PRELIMINARY  
 NOT FOR CONSTRUCTION  
 SUBJECT TO APPROVAL  
 SEP 17 1992

C		SITS, SHARON ANITY RD. PHASICOTTE, N.C. 28711	
B		TANK/AUTO MAINT. FACILITY DUNCAN ST. & MAIN SERVICE RD. CAMP LEJEUNE, N.C.	
Revisions	Date	Appd.	
Supervised	Drawn By: W.R.W.	Date: 9-14-92	DRAWING 929-51618-1X1
Supervised By	Approved By:	Sheet 1 of 9	NUMBER

HONEYWELL INC.			
517 S. SHARON ANITY RD. CHARLOTTE, N.C. 28211			
TANK/AUTO MAINT. FACILITY DUNCAN RD. & MAIN SERVICE RD. CAMP LEJEUNE, N.C.			
Revisions	Date	Appd.	Rev.
Superseded	Drawn By: H R W	Date: 9-15-82	DRAWING 939-81618-2X.I.
Superseded By	Approved By:	Sheet 2 Of 9	NUMBER

**UNIT HEATERS NO. 1 & 2, READY ISSUE**  
 SPACE TSTAT SHALL CONTROL UNIT HEATED FAN TO MAINTAIN SPACE AT 68°F. NITE SETBACK TSTAT (TRU) TIME SWITCH SHALL CONTROL UNIT HEATED FANS TO MAINTAIN SPACE TEMP. @ 55°F. PROVIDE OVERRIDE SWITCH FOR UNIT HEATER CONTROL WITH OVERRIDE CAPABILITY UP TO 6 HOURS.

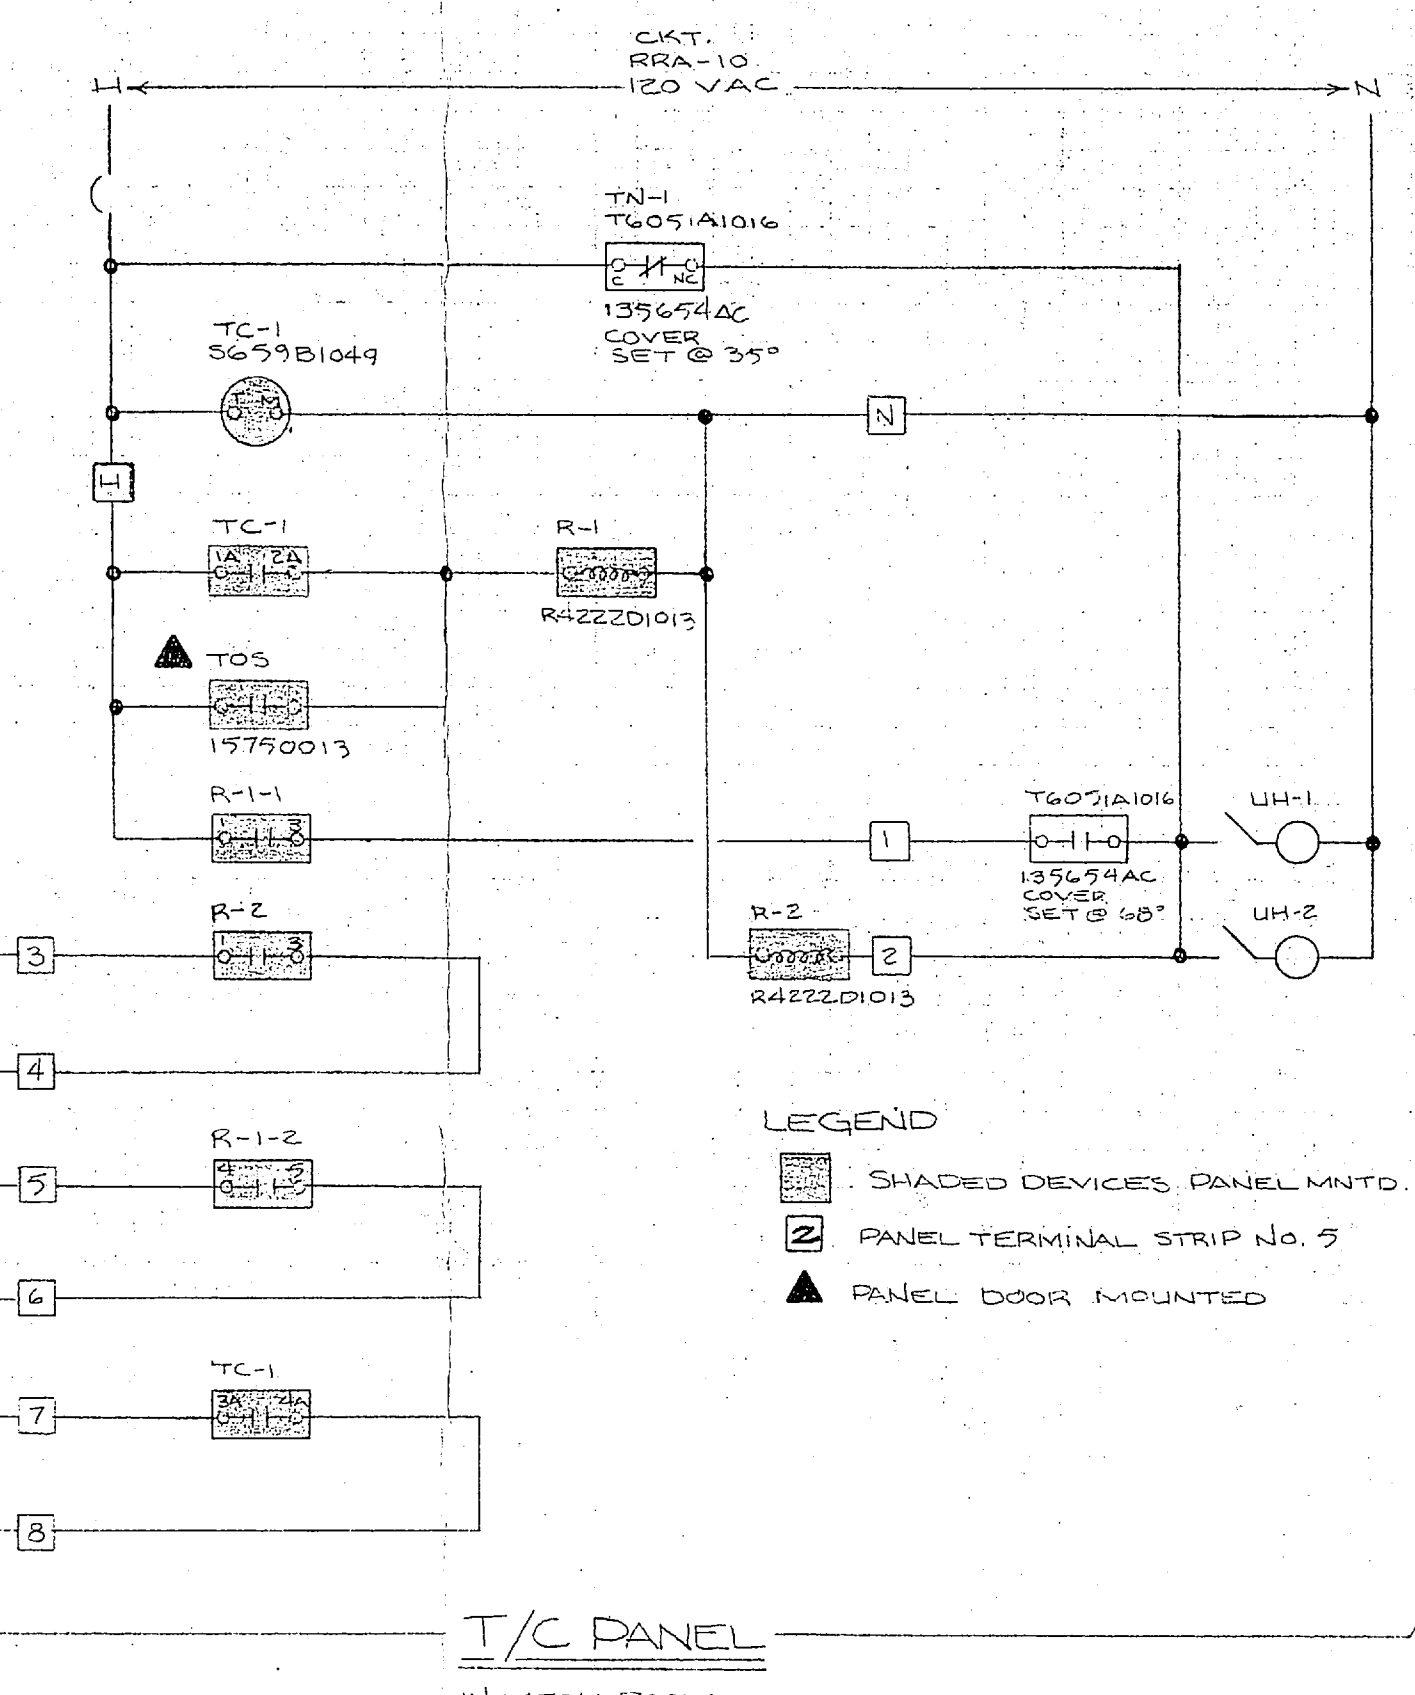
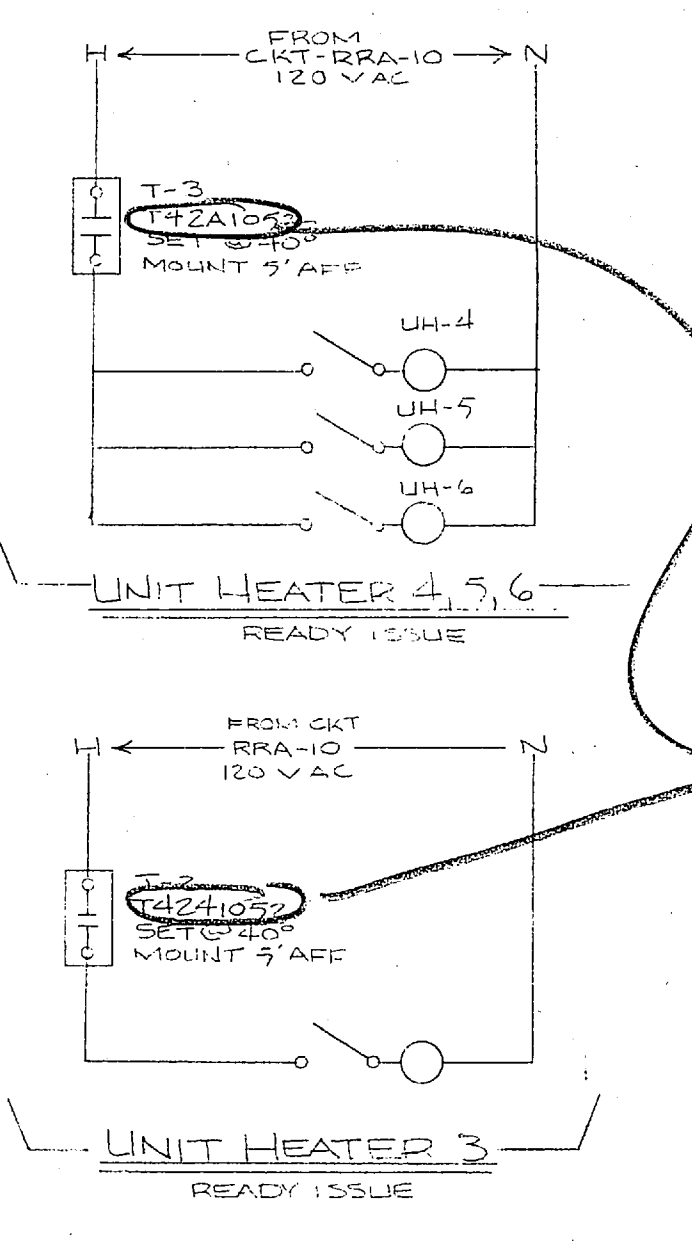
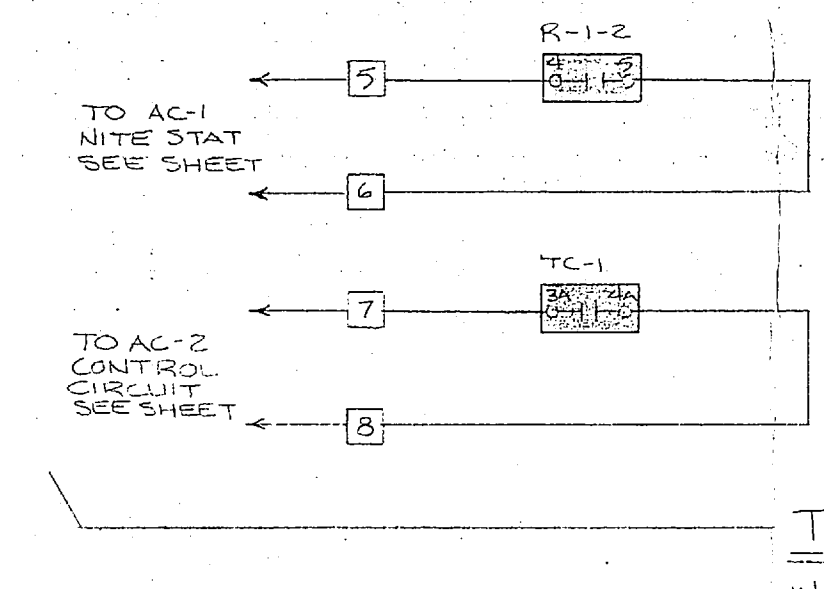
*DOES NOT MEET SPEC*
